MORKRUM MULTIPLEX PRINTING TELEGRAPH SYSTEM

METHOD FOR MAKING CHANGES

This supplement forms a part of Morkrum Specifications #111 and #112 dated January 1923 and February 1926, and covers the following new features:

**WIRING DIAGRAM
AS2**

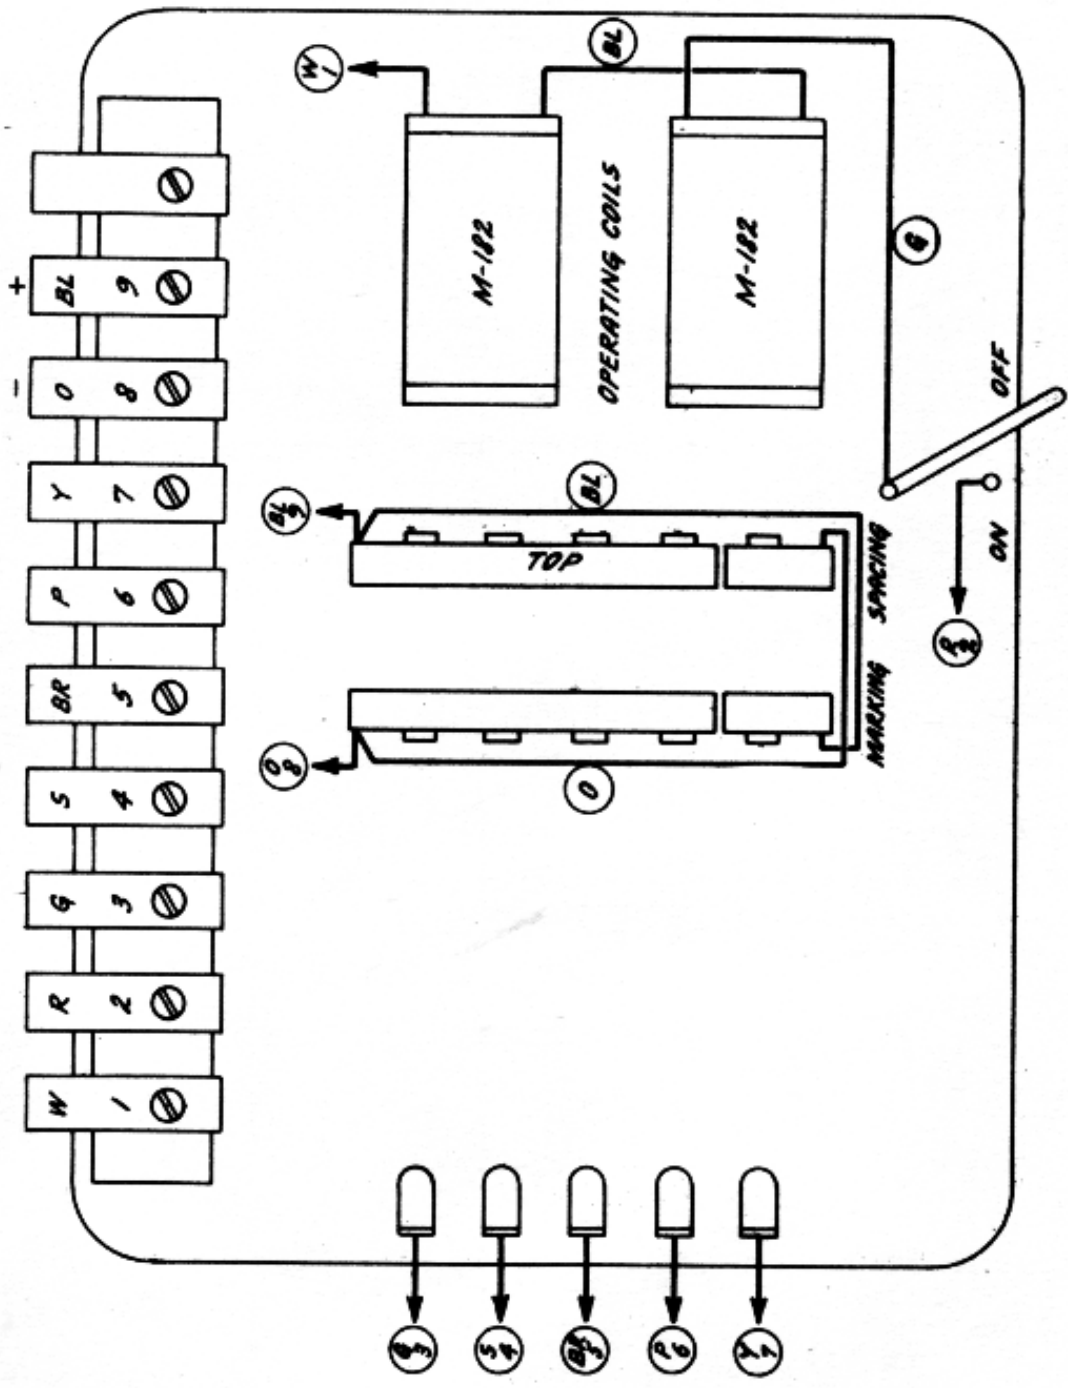
**CIRCUIT AND RELAY CHANGED
APRIL 5, 1927. A.S.B.**
